Wednesday, June 3, 2026
Planning Commission

A. CONSTRUCTION STANDARDS REVISION (26.01). This proposal involves various updates being made to the City's Construction Standards.

Construction Standard Drawings

SPANISH FORK CITY 40 SOUTH MAIN STREET SPANISH FORK, UT 84660 (801) 804-4550	**STANDARD DRAWING** 600 AMP PSE 3/5 SWITCHGEAR	DRAWN: TC DESIGN: TC REVISION: KT DATE: 3/12/2026	SCALE NONE STANDARD E-614

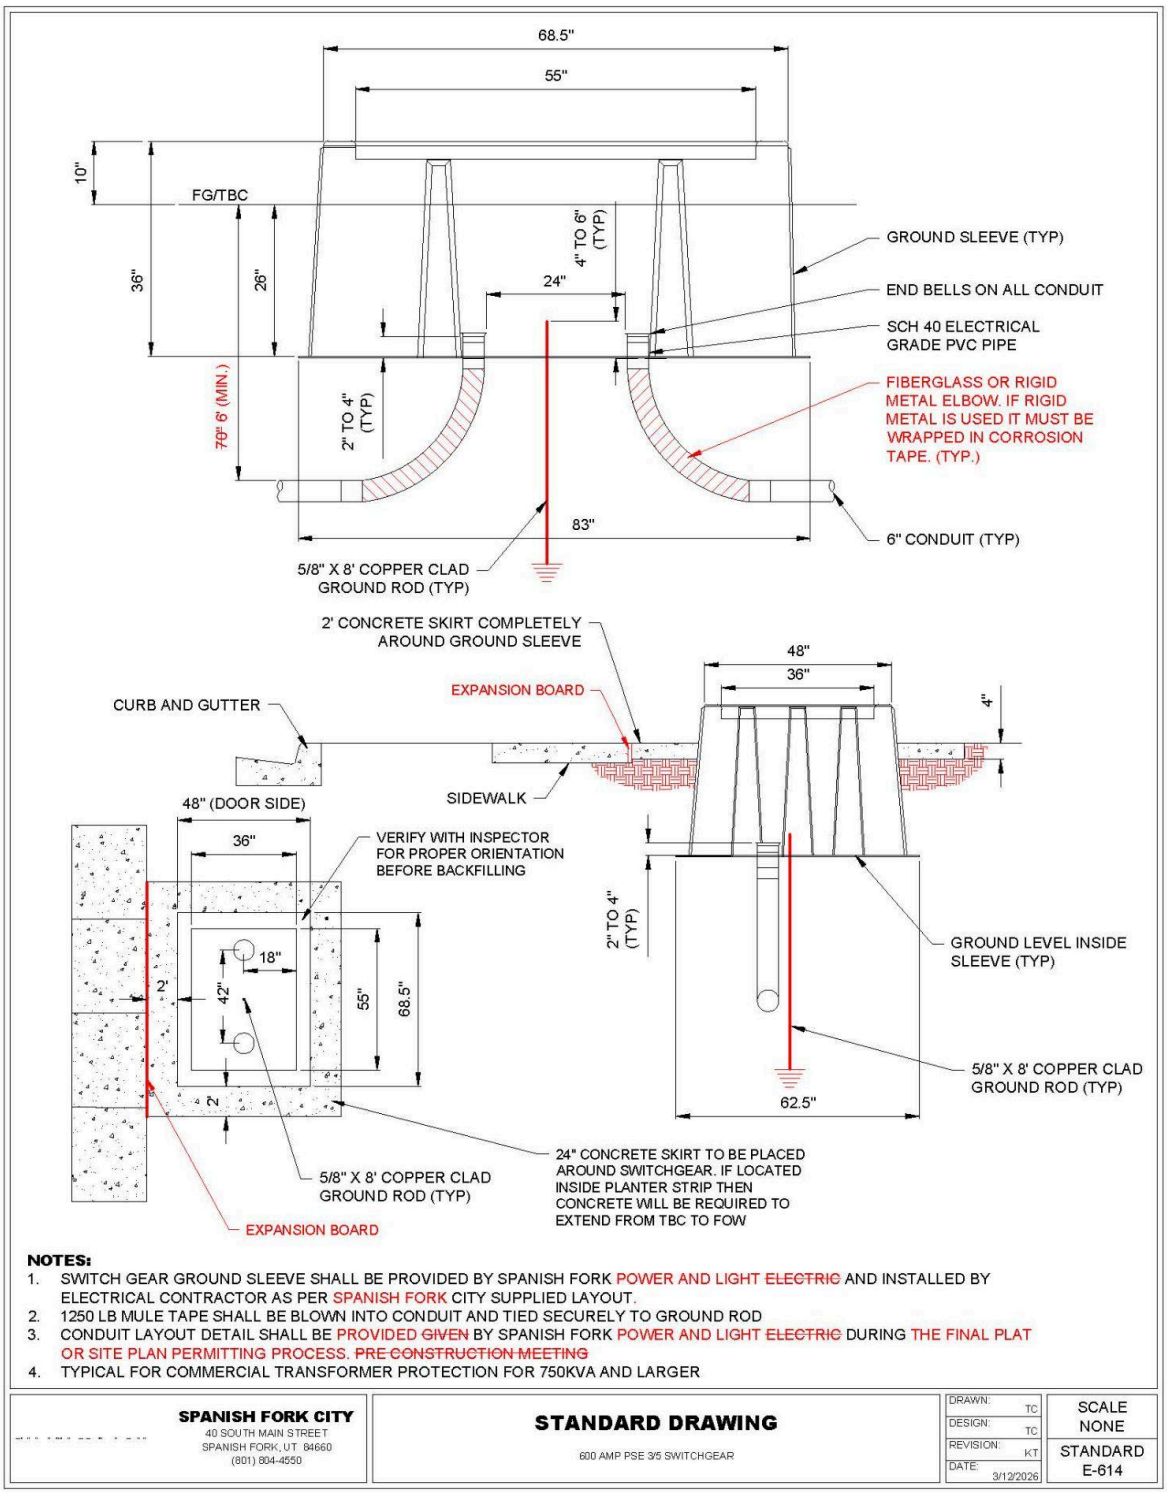
1. SWITCH GEAR GROUND SLEEVE SHALL BE PROVIDED BY SPANISH FORK POWER AND LIGHT ~~ELECTRIC~~ AND INSTALLED BY ELECTRICAL CONTRACTOR AS PER SPANISH FORK CITY SUPPLIED LAYOUT.
2. 1250 LB MULE TAPE SHALL BE BLOWN INTO CONDUIT AND TIED SECURELY TO GROUND ROD
3. CONDUIT LAYOUT DETAIL SHALL BE PROVIDED ~~GIVEN~~ BY SPANISH FORK POWER AND LIGHT ~~ELECTRIC~~ DURING THE FINAL PLAT OR SITE PLAN PERMITTING PROCESS. ~~PRE-CONSTRUCTION MEETING~~
4. TYPICAL FOR COMMERCIAL TRANSFORMER PROTECTION FOR 750KVA AND LARGER

SPANISH FORK CITY 40 SOUTH MAIN STREET SPANISH FORK, UT 84660 (801) 804-4550	**STANDARD DRAWING** 3 PHASE UNDERGROUND SERVICE 201-800 AMPS	DRAWN: JLR DESIGN: MHC REVISION: KT DATE: 3/12/2026	SCALE NONE STANDARD E-619

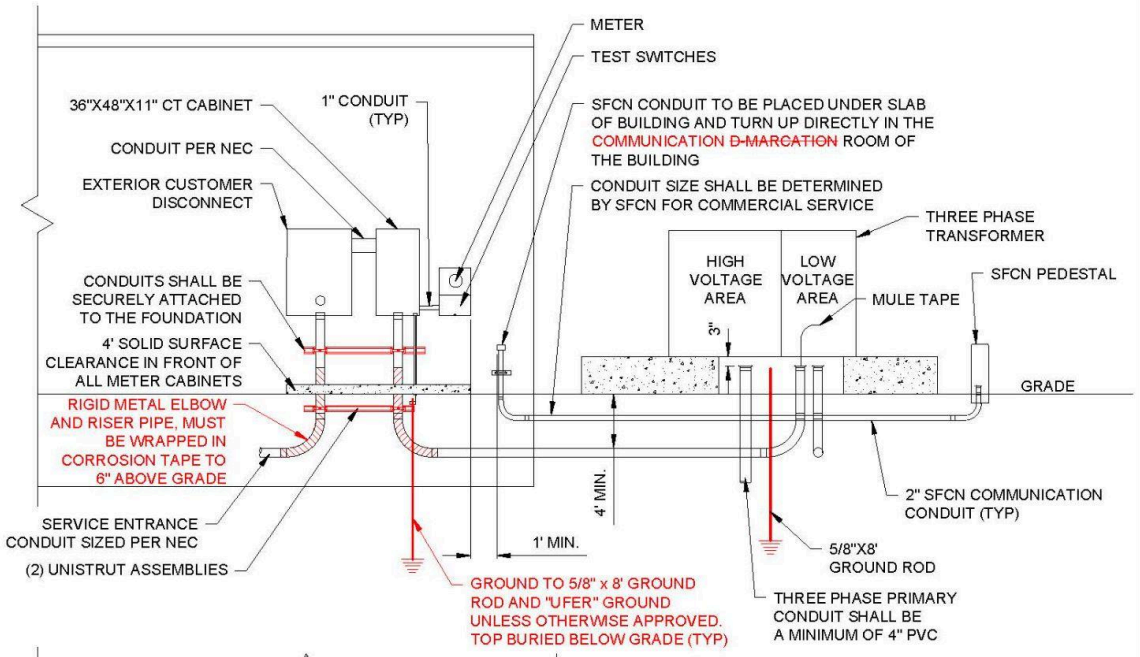
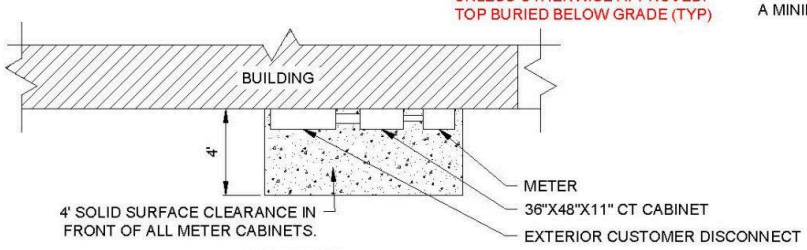
AMPS	PHASE	VOLTAGE
~~125-200~~ 400-800	1	240/120
~~125-600~~	~~3~~	~~208Y/120~~
~~601~~ 400-800 ~~1600~~	3	208Y/120 OR 480Y/277
~~1601-ABOVE~~	~~3~~	~~480Y/277~~
